RE: BEHS PSC - BG 25-145 - Change Order #18 - Lighting Changes

Change Order

Change Order Request 19 - PCO #50 - RFP-9 Electrical Revisions for Ductwork Changes

REQUEST FOR PROPOSAL

1 BULLITT EAST FIRST FLOOR PLAN - LIGHTING
SCALE: 1/8" = 1'-0"

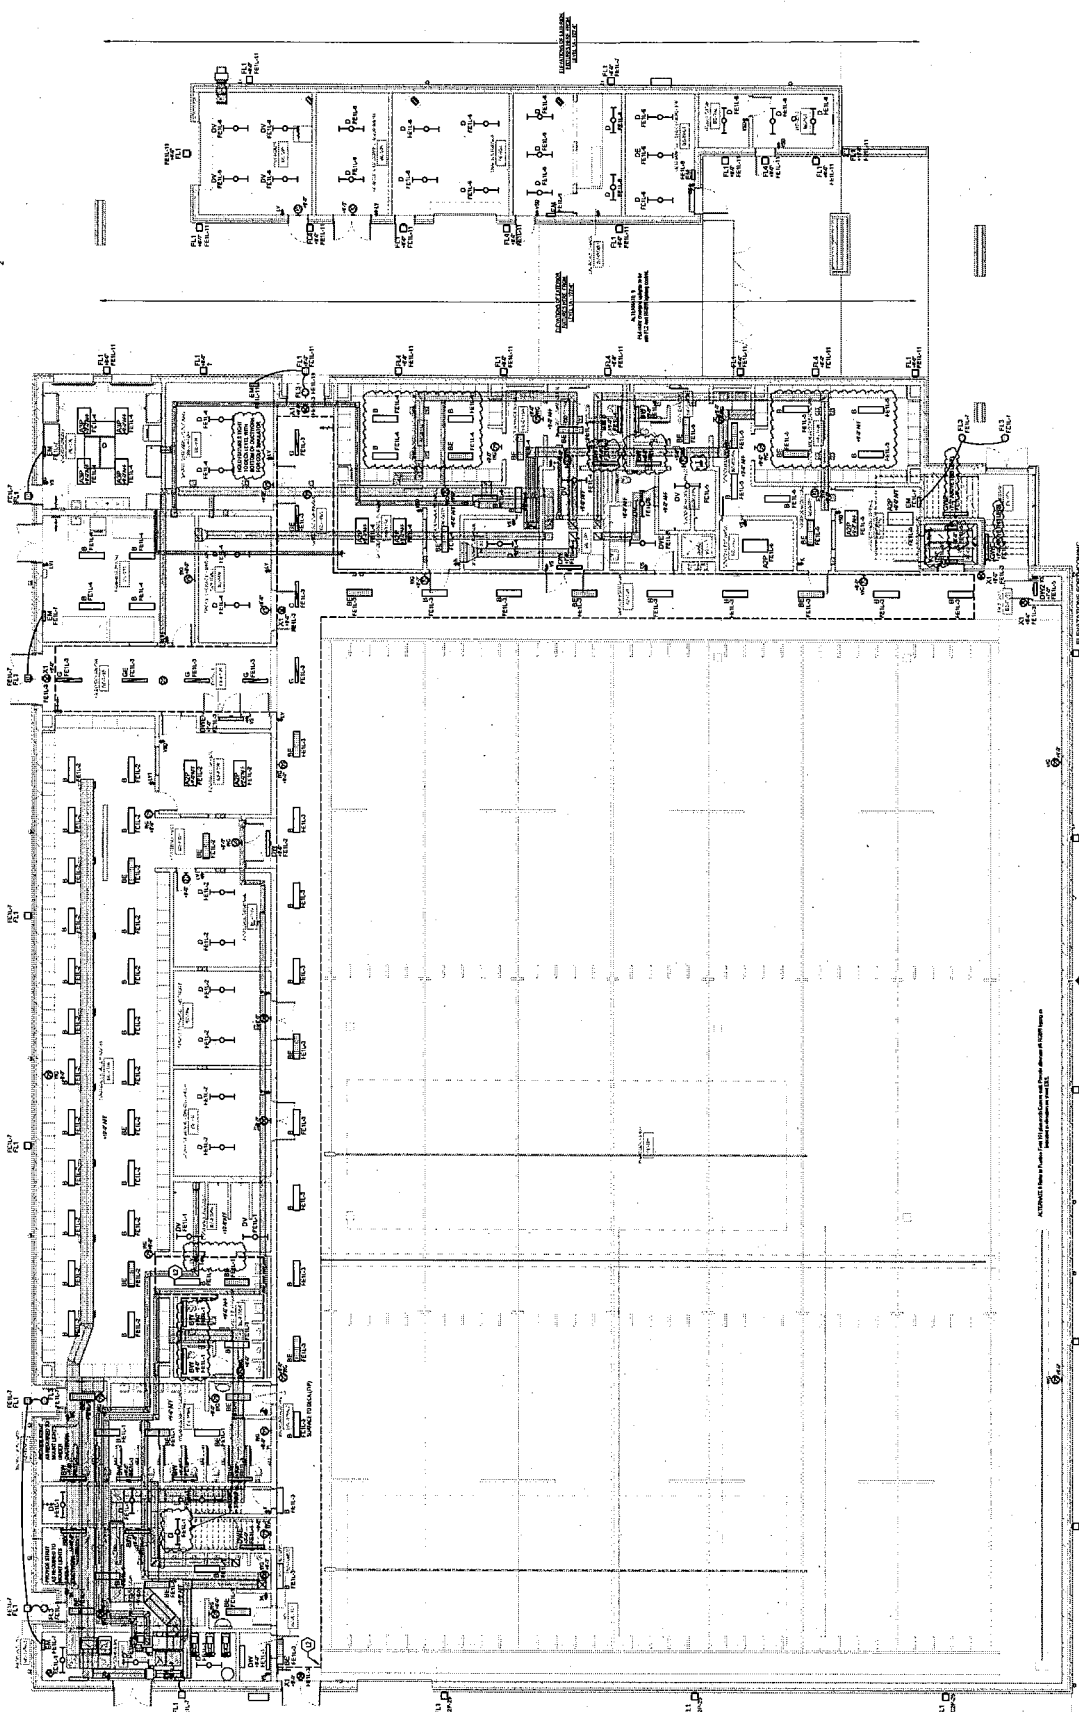
- Item No.1** This RFP includes work related to light/electrical routing changes relative to Ductwork revisions at the 2nd floor locker rooms. This RFP only includes scope for the electrical contractor. Work related to other trades is covered under CO 15.
- Item No.2** Refer to E1.21 BEHS
- Revised light fixture heights and added additional light fixtures.
- Item No.3** Refer to E1.22 BEHS
- Revised light fixture heights and added additional light fixtures.
 - Relocated emergency battery inverters to match NORTH.
